IMPORTANT NOTICE – RECALL

Replacement of Cap for Valve Body Assy

Yamada Corporation has determined that a defect may exist in some of our Air Operated Diaphragm Pump NDP-P20/20-PP and P25/25-PP series.

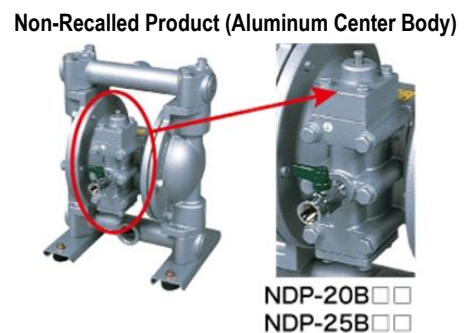
Cap A (part number 772946) and Cap B (part number 772947) are located at the top and bottom of Valve Body Assy. The defect is that some of the plastic screw parts of Cap A and Cap B have shrunk and are smaller than the ones at the original molding stage. If the defective pumps are operating, the cap may come off from the valve body assy, and it might hurt human body in worst case.

We shall provide replacement parts free of charge.

If your pump apply to NDP-P20/20-PP and P25/25-PP series in the attached list, please contact Yamada Corporation or your nearest dealer immediately.
